Final Response to March 2004 Technical Review Panel Comments on the January 2004 Initial Response to the September 2003 Technical Review Panel Report (May 2004)

Comments on the Initial Response to the Technical Review Panel Report For the Battle Creek Salmon and Steelhead Restoration Report

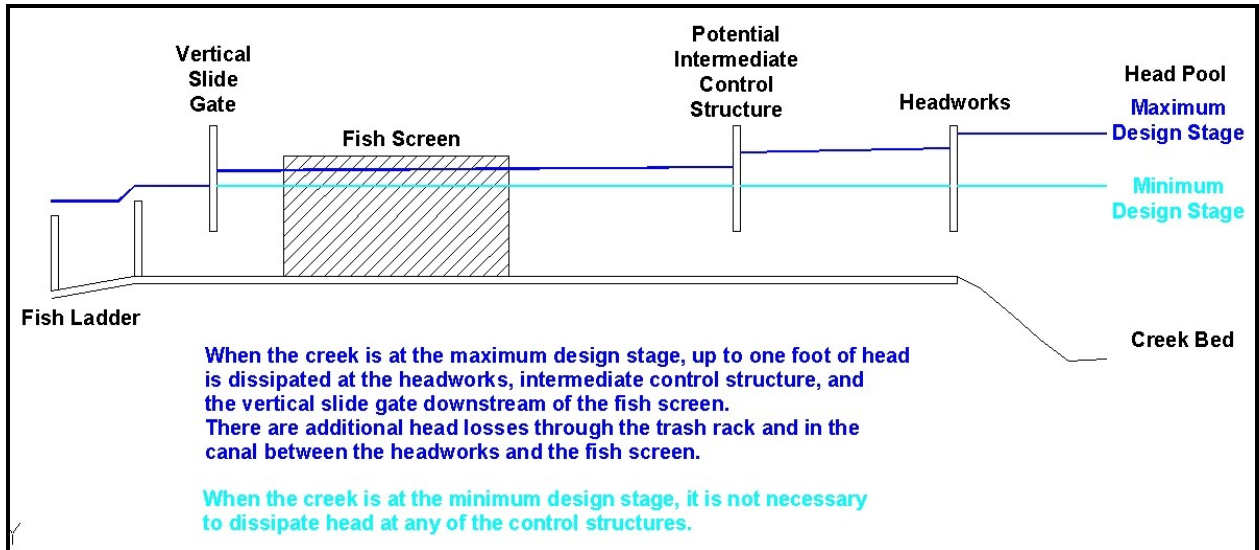
2.6.1.1.1: TRPR Abbreviated Comment d: “Throttling several feet of head with entrance gates may not provide appropriate fish passage conditions.”

TRP comment: “PMT Response: This is a very technically complex part of the fishway design.” The TRP concurs with the PMT statement. But the PMT largely ignored the Review Panel’s comments and experience with fish screens in this region. Instead, they suggested that they had consulted with relevant agencies and did not address the Panel’s concerns.

In the September 2003 report, the Panel commented that throttling several feet of head with entrance gates may not be appropriate. The PMT understood this to mean the first

The PMT concurs that throttling several feet of head at the headworks is inappropriate and reiterates that the facility was not designed to operate that way. The maximum possible head differential between the pool upstream of the dam and the normal operating water surface elevation at the fish screen will be 3.5 feet. During normal operating conditions the water surface elevation at the fish screen will be the same as at the upstream end of the fish ladder.

If a 3.5 foot head differential were to occur, the gate at the downstream end of the fish screen (the bypass gate) will be partially closed, raising the water surface elevation at the fish screen by 1-foot. The water surface elevation at the upstream end of the fish ladder will remain unchanged and there would then be only 2.5 feet of head difference between the water surface elevation of the pool upstream of the dam and the water surface at the fish ladder.

The gates at the headworks control the water entering the canal and will dissipate up to 1-foot of head. Local losses within the canal, between the headworks and the fish ladder, dissipate another 0.5 feet of head, for a total loss of 2.5 feet.

Since it is possible, but unlikely, that a 3.5-foot head differential could occur during the design flow range, the final designs incorporate a structure within the canal, upstream of the fish screen, that would be used to dissipate the additional foot of head, if necessary. The structure is included in the contract drawings, but the gates and appurtenances are not; they will be installed later, through adaptive management, if the head differential approaches 3.5-feet.

Of course, the facility operators would never actually wait for a large head differential to occur before taking corrective action. Before that situation arose, gates would be adjusted incrementally to insure that the maximum difference across any structure did not exceed one foot.

In summary, should a 3.5-foot head differential occur, then 3 feet of head would be dissipated across three different structures (1-foot per structure) spaced out over 300 feet of canal, and the balance of head would be dissipated by local losses.

Note: The slide gate shown in the graphic above will be changed to a swing gate.
